# CITY OF RICHMOND INVITATION TO TENDER

### Contract: Francis Road Drainage Pump Station

**Re: Contract T.2970  
Addendum No. 1  
Drainage Pump Station Renovation  
Francis Road Drainage Pump Station**

**Re: Contract T.2970  
Addendum No. 2  
Drainage Pump Station Renovation  
Francis Road Drainage Pump Station**

SHEET 1 OF 2      DWG. No. 411-U07-D2899      R. 6

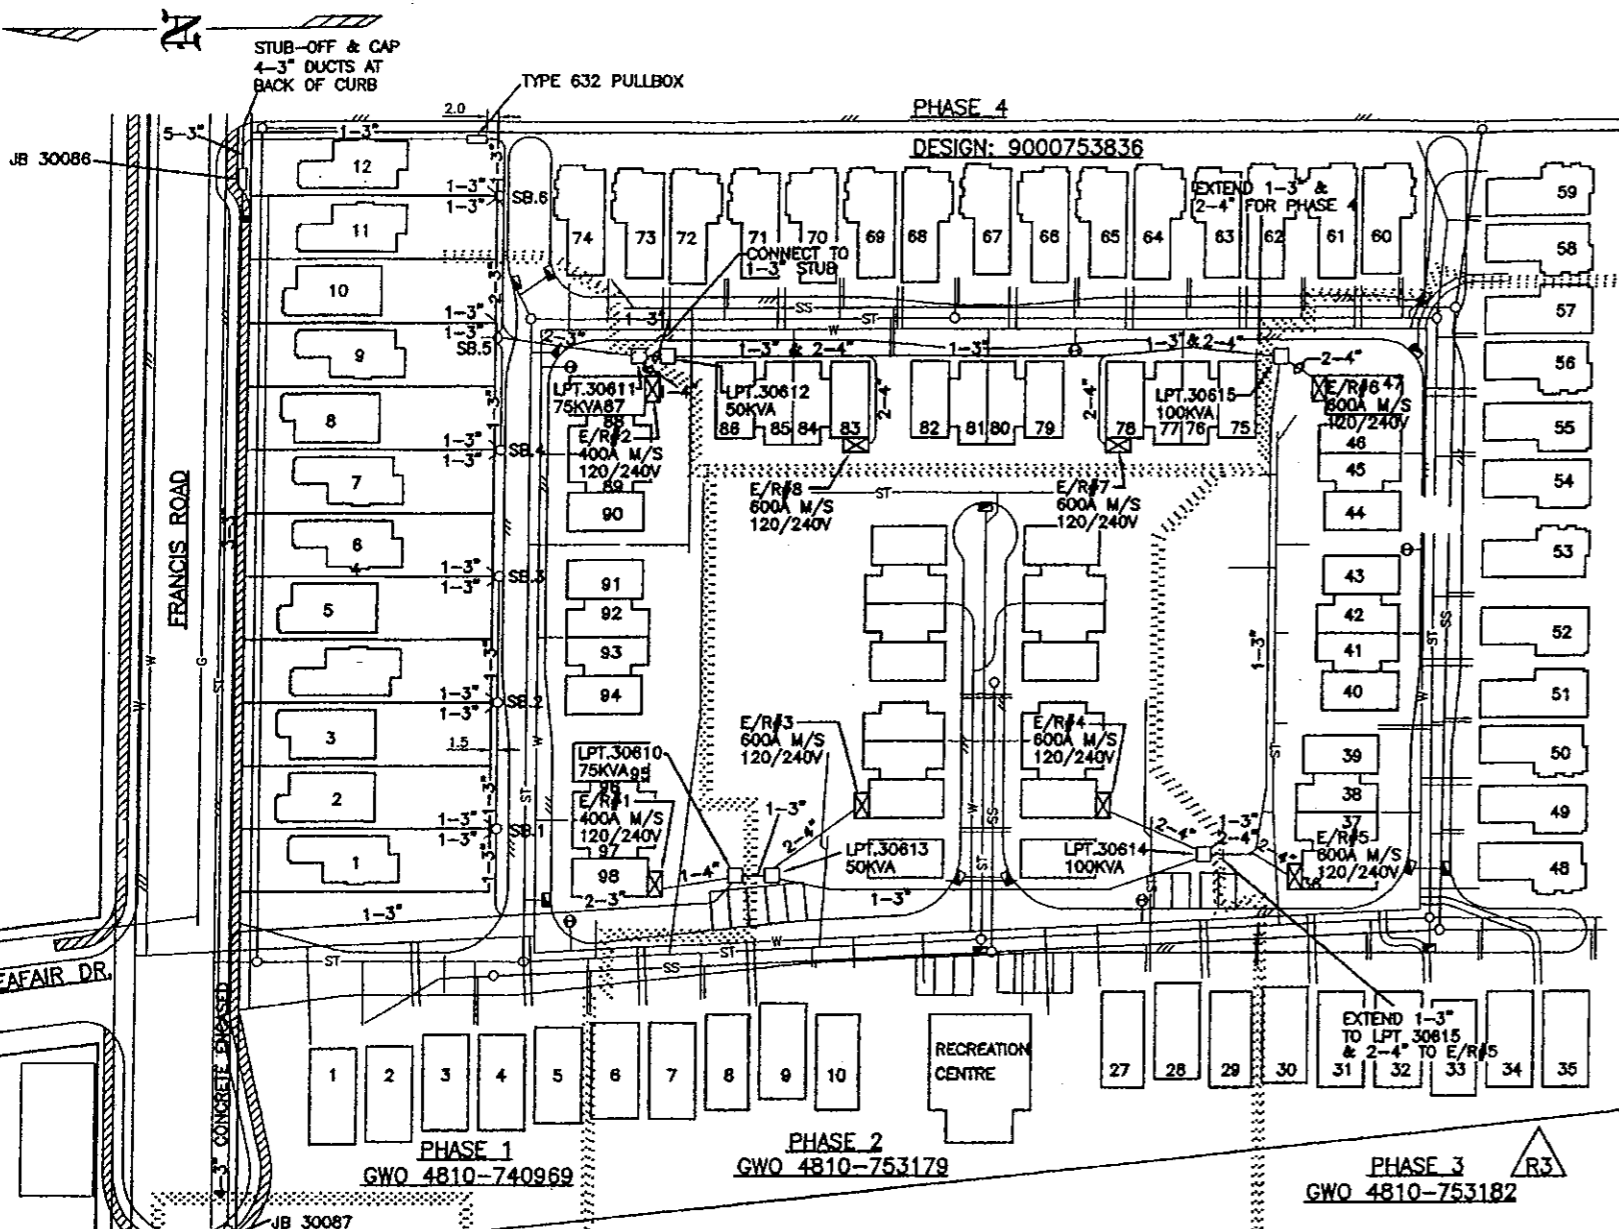
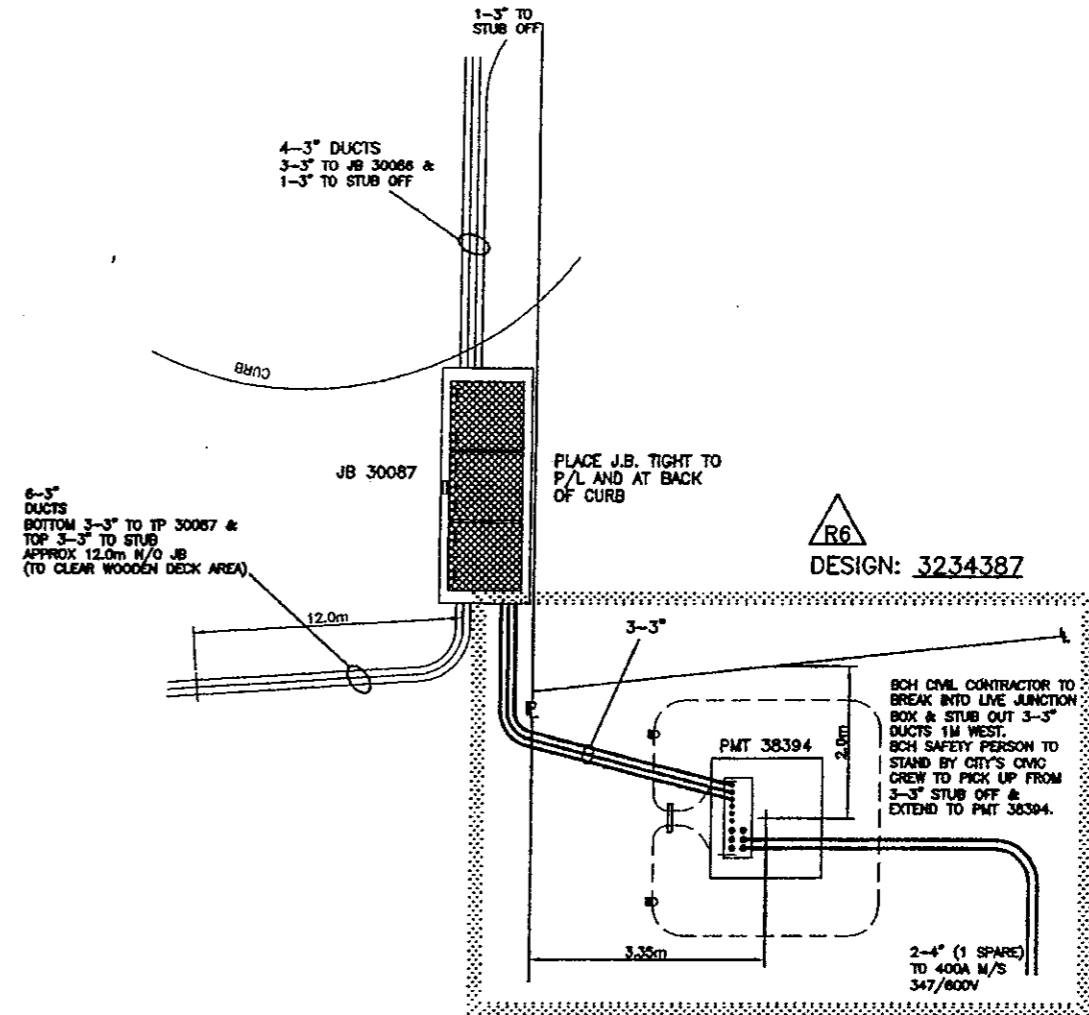
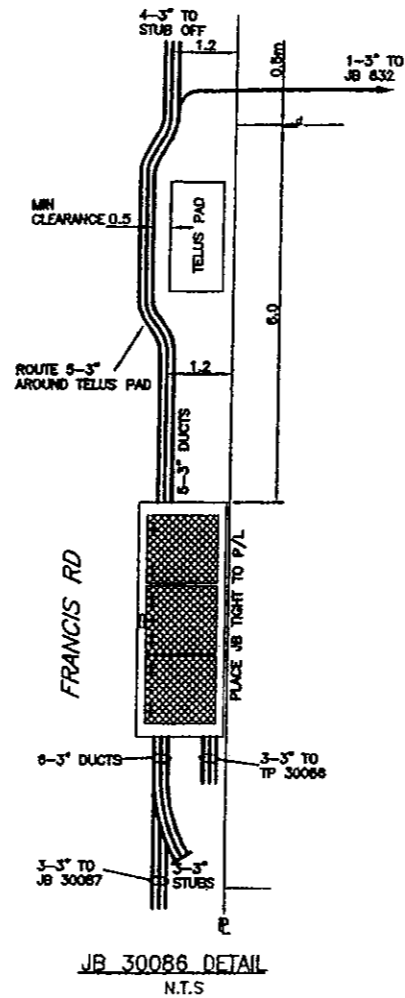
4. After Page M-1, Section M Building Permit, insert the attached the new Section N, BC Hydro Materials and the attached BC Hydro letter dated August 11, 2006 and Drawing No. 411-U07-D28999, Sheets 1 and 2 of 2.
